WELL API NO. 30-025-36221
5. Indicate Type of Lease STATE <input type="checkbox"/> FEE <input checked="" type="checkbox"/>
6. State Oil & Gas Lease No.
7. Lease Name or Unit Agreement Name DIAMOND
8. Well Number 3
9. OGRID Number 240974
10. Pool name or Wildcat NADINE;SAN ANDRES, DRKD, ABO
11. Elevation (Show whether DR, RKB, RT, GR, etc.) 3599' GL

SUNDRY NOTICES AND REPORTS ON WELLS
 (DO NOT USE THIS FORM FOR PROPOSALS TO DRILL OR TO DEEPEN OR PLUG BACK TO A DIFFERENT RESERVOIR. USE "APPLICATION FOR PERMIT" (FORM C-101) FOR SUCH PROPOSALS.)

2. Name of Operator
LEGACY RESERVES OPERATING LP

Diamond No. 3 Wellbore Diagram

Current WB Sketch

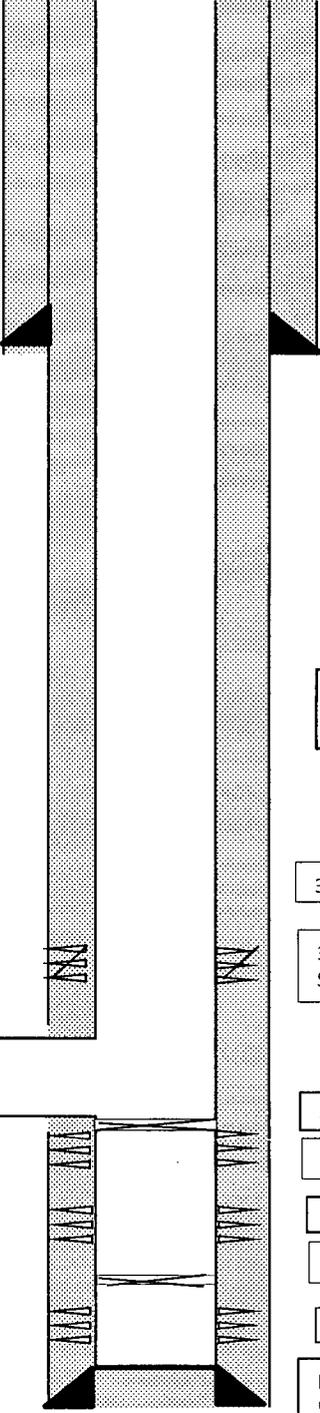
SET WITHIN 100' OF WINDOW - 4040'

Proposed TA Schematic

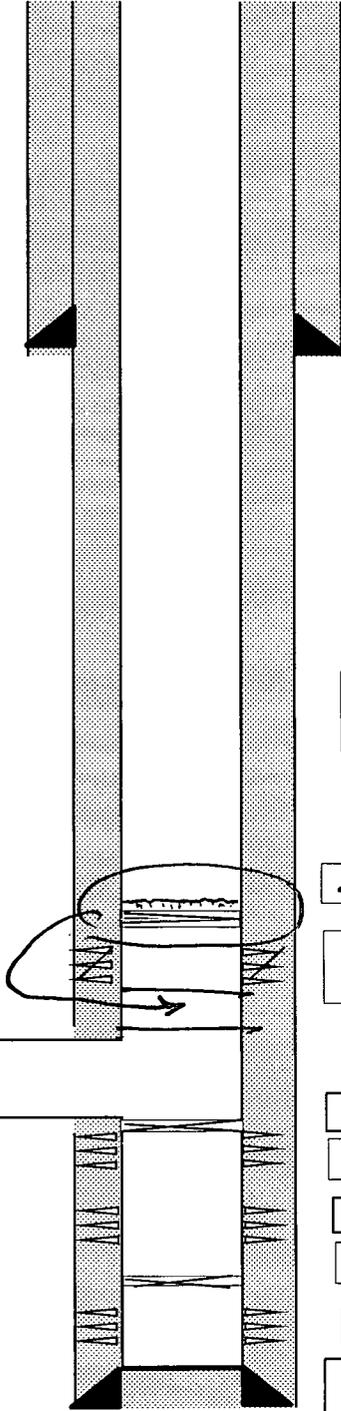
SET CIBP WITHIN 100' OF WINDOW. CAP WITH CMT. 4040'+

~~3380'~~-CIBP w/ 40' (4 sxs cmt)

Condition of Approval: notify

Rig Release Date: **OCD Hobbs office 24 hours prior of running MIT Test & Chart**
